ADDENDUM NO. 1 TO 20-0079-4

FOR: HENDERSON GOLF CLUB 18TH FAIRWAY STABILIZATION

DATE	10.14.2020
BY	KDH
REVISION	
ADDED CART PATH DETAIL, ADDED NOTE 8	
NUMBER	1
<p>CHATHAM COUNTY DEPARTMENT OF ENGINEERING 124 BULL STREET, SUITE 430 SAVANNAH, GA 31401 PHONE: (912) 652-7800 FAX: (912) 652-7818</p>	
<p>HENDERSON GOLF CLUB BANK STABILIZATION AT 18TH FAIRWAY</p>	
<p>CONSTRUCTION DETAILS AND NOTES</p>	
DATE:	5-1-20
DESIGNED:	KDH
APPROVED:	BRN
SCALE:	NTS
SHEET	2
OF	2

CART PATH DETAIL
NTS

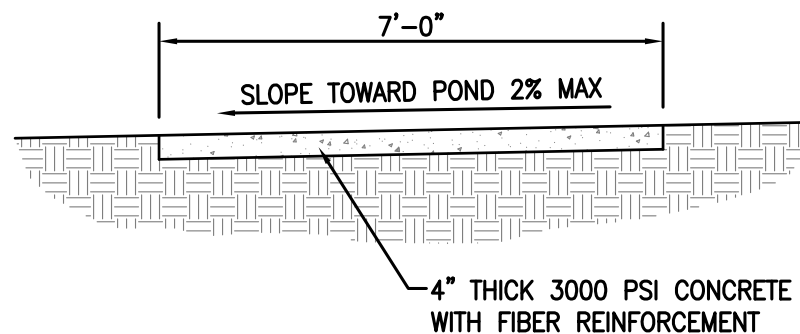
NOTE: Both of these revisions are due to the adding of concrete cart path and sod line to the Bid sheet and the concrete cart path detail to the plan sheet.

1. CONCRETE TO BE 4" THICK 3000 PSI CONCRETE MINIMUM WITH FIBER REINFORCEMENT.
2. COMPACT SUBGRADE TO 98% STANDARD PROCTOR.
3. CONTRACTION JOINTS SHOULD BE SPACED AT 10'-0" MAX AND BE 3/4" DEEP FORMED OR SAWED.
4. 1/2" EXPANSION JOINT SHALL BE INSTALLED EVERY 80'-0" MAX.
